FIRST REVIEW
WC³ Project #: 217-525-117

Subject: Huberman SFD – Plan Review Comments

Project Name: Huberman SFD

Location(s): 5741 North Daybreak Ridge, Eden, UT

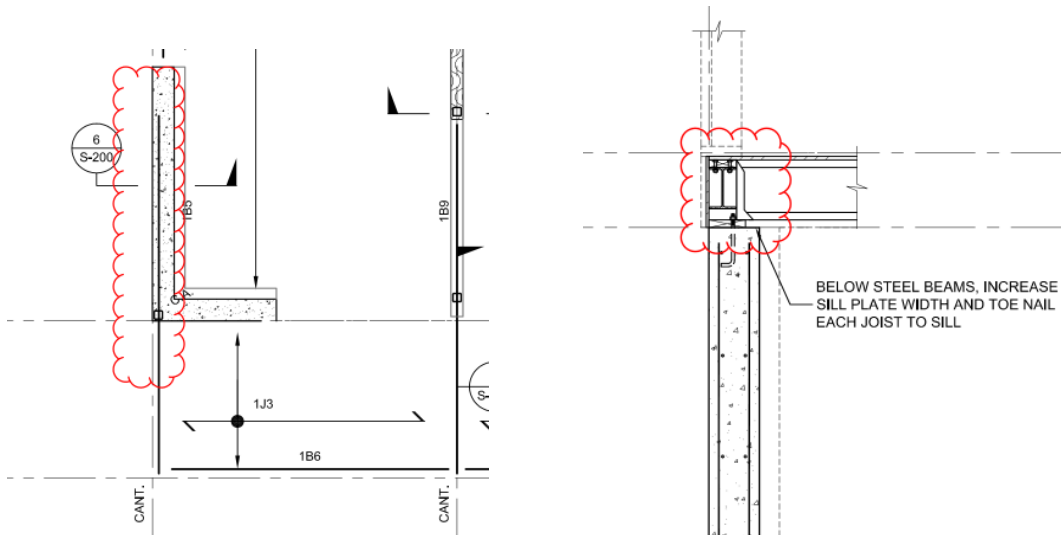
- N4. REScheck:
 - A. The report identifies Wall 1 with R-20 cavity insulation, as well as R7.5 continuous insulation. Provide a wall detail showing how the walls will be constructed and identifying the listed product being used to achieve the continuous insulation.

- B. The report identifies Wall 2 with R-6.7 cavity insulation, as well as R-20.1 continuous insulation. Provide a wall detail showing how the R-values are to be achieved for the concrete walls and identify the listed product being used to achieve the continuous insulation.
